# PLAN COMMISSION STAFF REPORT

**Agenda Item:** PC Docket No. 22-007

**Application Type:** **Development Plan**

**Summary:** Paul Kats on behalf of Munster Church, Inc. requesting of a development plan to permit the construction of an addition to the Munster Church, the construction of a new multipurpose accessory building, and associated site modifications at 214 Ridge Road.

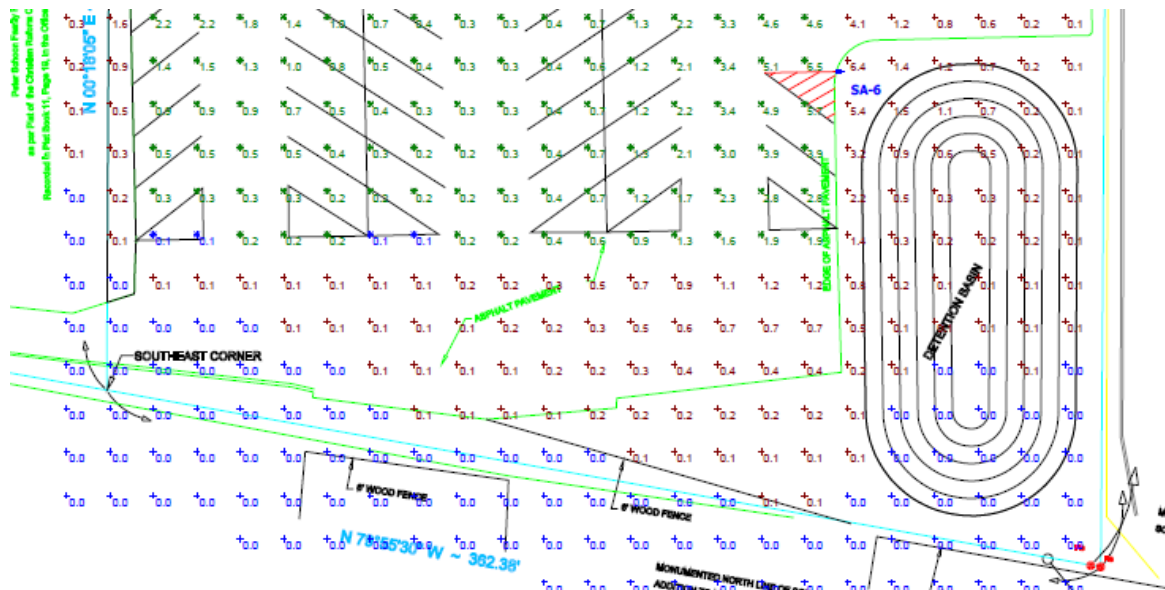
5. TABLE 26-6.405.B CIVIC ZONE STANDARDS Screens Parking, Loading Areas, Service Areas, Outdoor Storage, Drive-Throughs, Trash Receptacles/ Dumpsters, HVAC and other equipment Screened from Frontage, Civic Space and Adjacent Property Required; except at Driveways: Parking Lots and Parking Areas shall be Screened from Frontage and Civic Space by Building or Streetscreen; Parking Structures shall be Screened from Frontages by Liner Buildings. Otherwise, Screening shall be by Building, Wall, hedge or Fence at Frontage or Building, Wall, hedge or Fence not at Frontages or Adjacent to Civic Space.

**Required:** The parking area must be screened from the residential properties to the south by a six-foot fence or hedge.

**Proposed:** Some existing residential fences and some intermittent landscaping is already present south of the parking areas. A 6' vinyl fence is proposed along the south edge of the east parking area.

Figure 9 Location of new landscape islands.

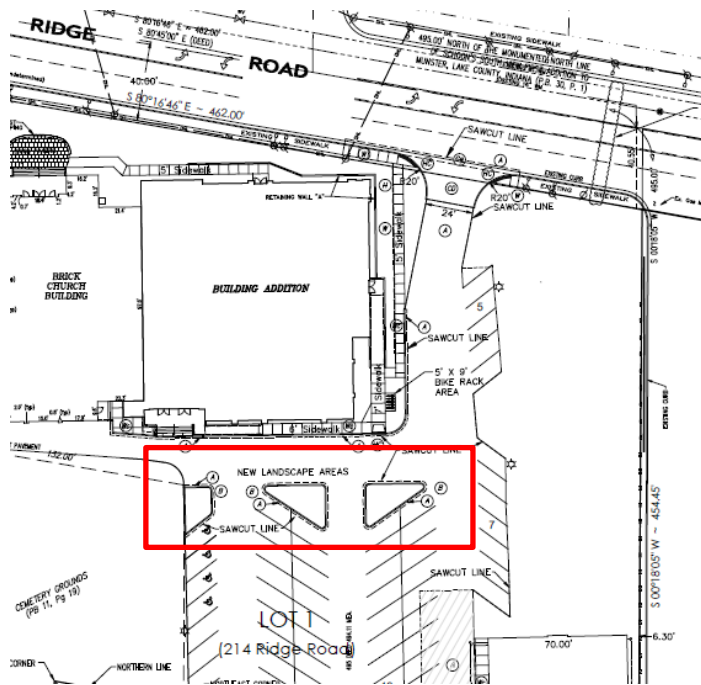
1. SECTION 26-6.405.O.1.h.vii.l.1) Parking Areas and Parking Lots shall contain at least one landscape island for every ten (10) parking spaces. Parking Lots with more than one landscape island shall have such islands distributed throughout the Parking Lot.

**Required:** Landscape islands are required to be installed in existing parking lots when a new building is constructed, but the requirement can be waived if they can't be installed without removing required parking spaces. In this case, there are 18 existing areas at the ends of parking rows that can be converted from asphalt to landscape islands.

**Proposed:** Only three new landscape islands are proposed south of the building addition.
